# Work Order ID 99889

Item Name: Crosstube Turning Detail

DRAWING NO. D212-664-141	TITLE XTUBE ASSY (205/212/412 HI FWD)	REV. D	DART AEROSPACE LTD ENGINEERING ORDER		D.E.O. NO. D212-664-141-D-1	SHEET NO. SHEET 1 OF 2	SCALE NTS
DRAWN	CHECKED	MP	MFG. APPR.	APPROVED	MP	DE APPR.	
DATE 11.04.07	DATE 11.07.11		DATE 11.04.12	DATE 11/04/12		DATE 11.04.12

DRAWING NO. D212-664-141	TITLE CROSSTUBE ASSY (205 HI FWD)	REV. D	<b>DART AEROSPACE LTD ENGINEERING ORDER</b>	D.E.O. NO. D212-664-141-D-2	SHEET NO. SHEET 1 OF 1	SCALE NTS
DRAWN <i>MP</i>	CHECKED <i>AS</i>	MFG. APPR. <i>AS</i>	APPROVED <i>MP</i>	DE APPR. <i>MP</i>		
DATE 11.07.15	DATE 11.07.20	DATE 11.07.21	DATE 11/07/21	DATE 11.07.21

**D212-664-141/-141B  
ASSEMBLY DETAIL**

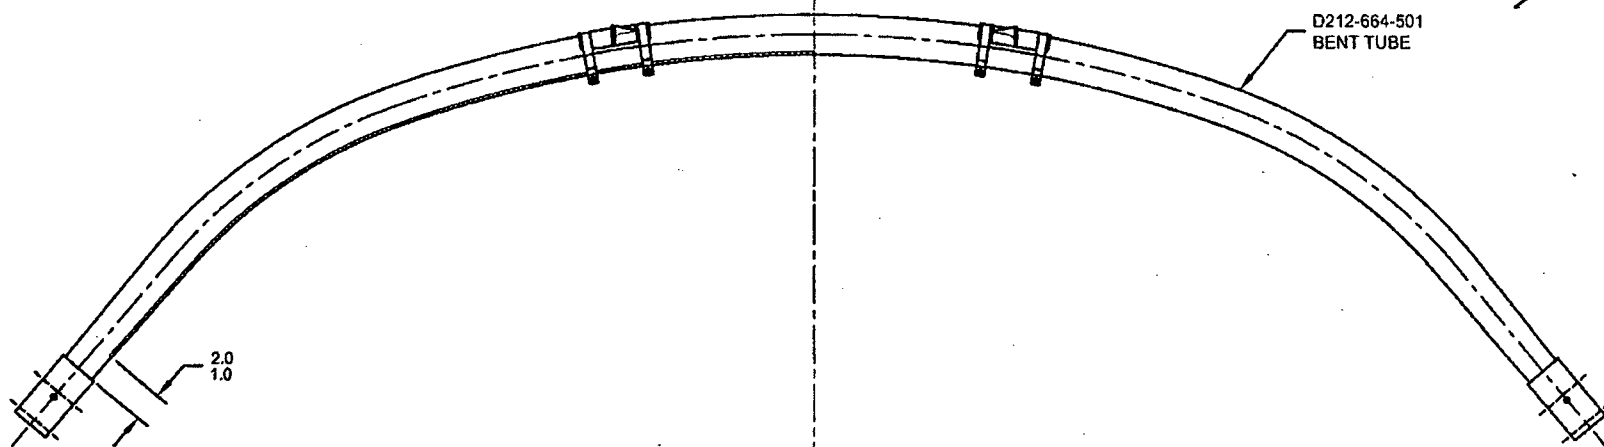
**PURPOSE:**

ADD AN INSPECTION WINDOW TO UNDERSIDE OF CROSSTUBE.

**CHANGE:**

IS:

WAS:

MASK AREA PRIOR TO PAINTING,  
REMOVE MASKING AFTER PAINT  
AND APPLY CLEAR COAT
